AUTHORS: We thank Referee 1 for her/his time, work and the constructive comments. This helped to improve and clarify our manuscript. For the review process we reply to the general review comments (GRC) in three subitems. For the specific review comments (SRC) we changed the tabular form to running text and added numbering.

Anonymous Referee 1

Received and published: 5th August 2019

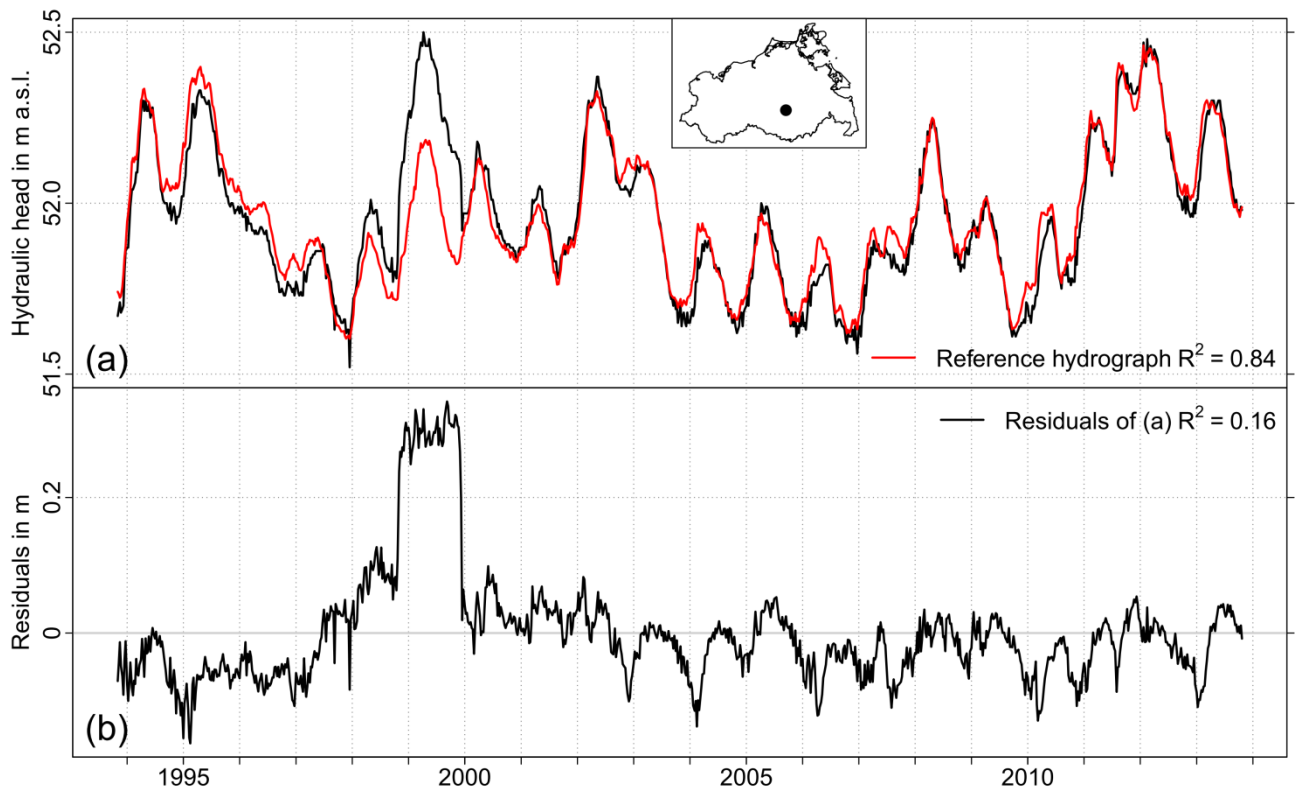
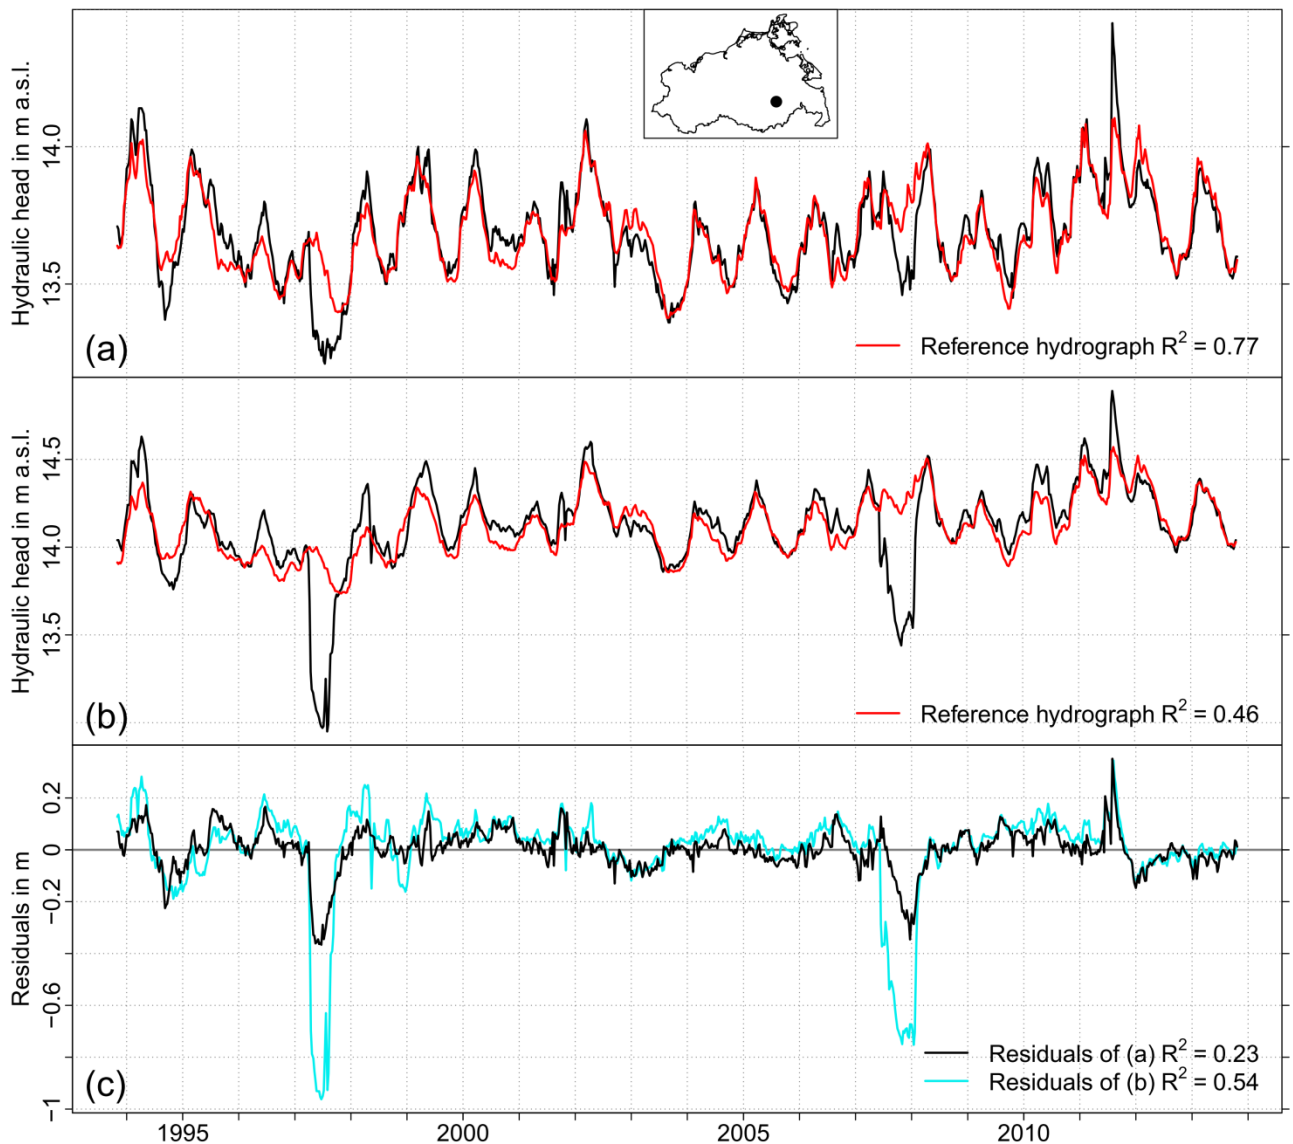
REFEREE SRC #12 Line 281: “a series of minor deviations before 1997 and another relatively strong deviation in 2011 (Figure 7b and d)”. It is difficult to make this out. Can you add minor tick marks to the x axis on both Figure 6 and 7? The “relatively strong deviation” looks like it is later than 2011.

REFEREE SRC #13 Figure 6&7: The use of colour is not great, and will be indiscernible for those with (common) redgreen colour blindness. Why not use dotted and dashed lines, and please add a legend to each plot, which will make it quicker to differentiate between the reference and observed hydrographs. I think the eight lines in the very top right of the figure should be moved to their relevant position in each plot (box)

AUTHORS: We gave a stronger grey for the grid in the background and added minor tick marks to the x axis of both figures. We furthermore changed the colours and placement of the legend according to your suggestions in SRC #13.

AUTHORS: We changed the figures according to your suggestions. Please see our reply to SRC #12.

Figure S1 Dates of reading of groundwater head of the eight series which exhibited marked deviations from the quasi-weekly reading interval. Daily reading intervals appear as black solid line.

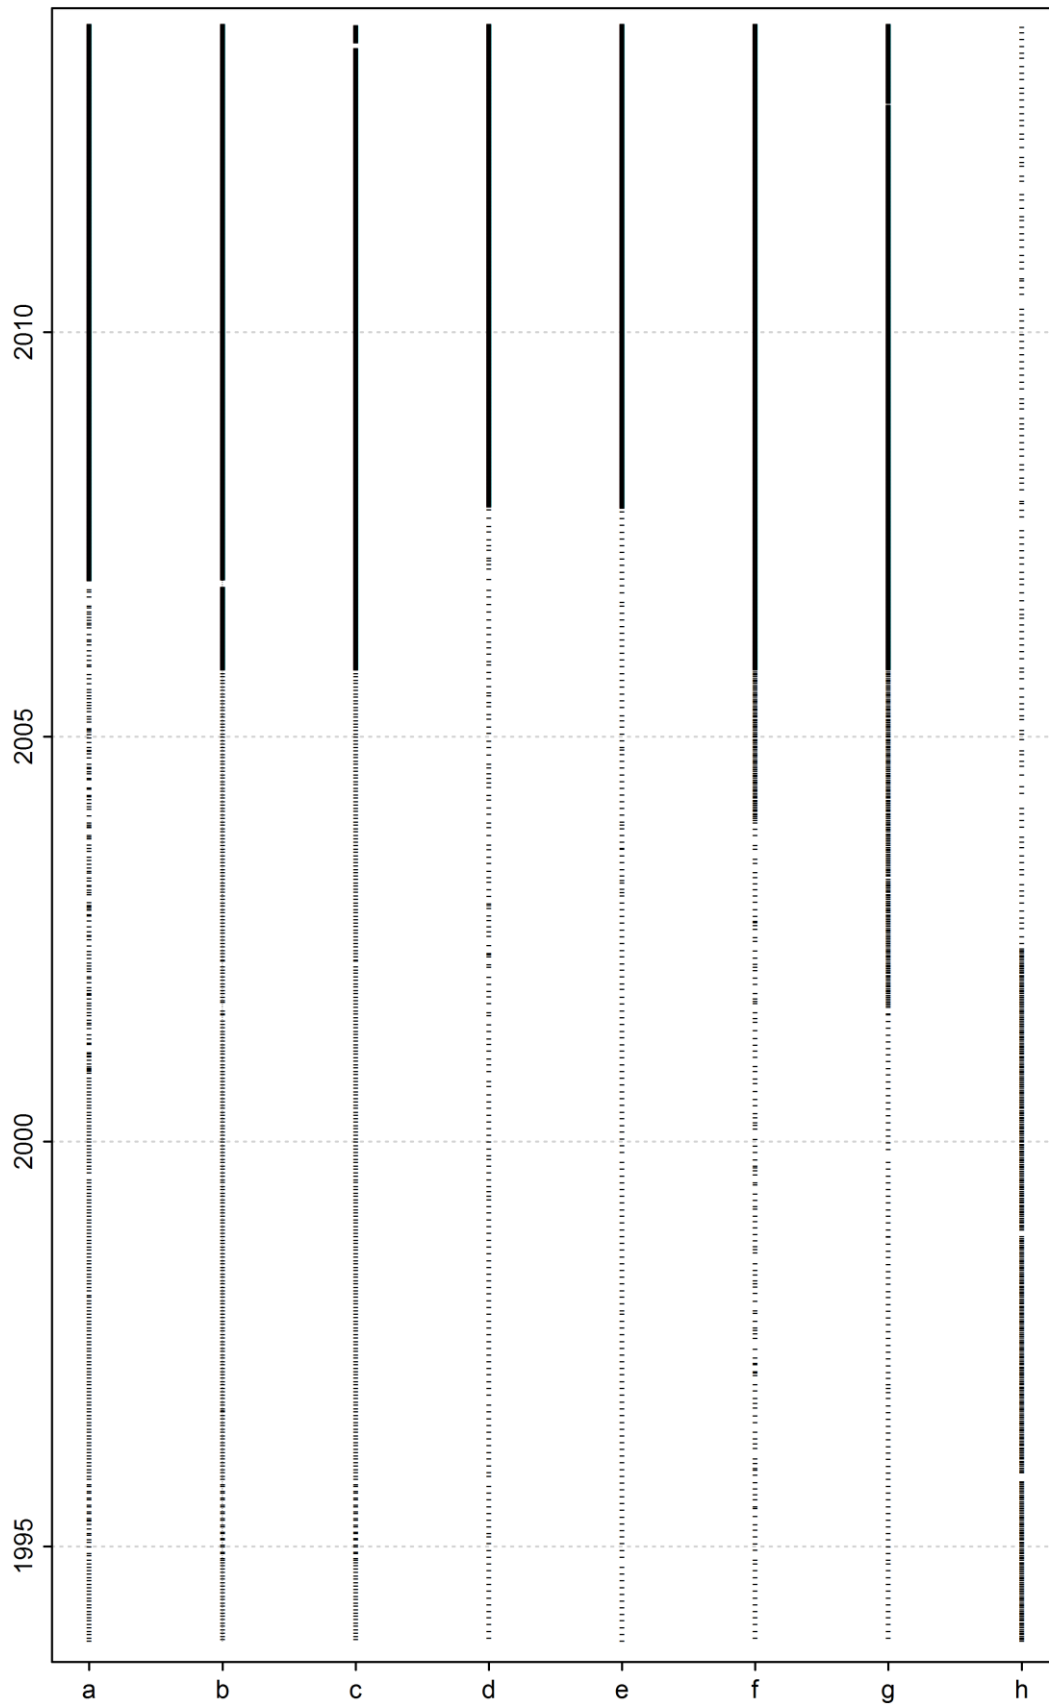
REFEREE SRC #16 Figure S1: This figure doesn’t provide the reader with much (if any) useful information/knowledge about the dataset. Much better would be one/some plots summarising some of the statistical properties of the observations e.g. density plots summarising changes in the frequency of measurement over time would provide more useful information.

AUTHORS: We changed the figure such that we show now only the eight series which exhibit marked deviations from the quasi-weekly sampling interval, see also our reply to SRC #8.

Regarding the content of the figure we think that It gives at one glance the information during which part of the monitoring period deviations occurred.

We are open for your suggestion, but it is not clear to us how to summarise changes in the frequency of measurement over time for all series (or the selection of the eight series) with density plots in one single figure.
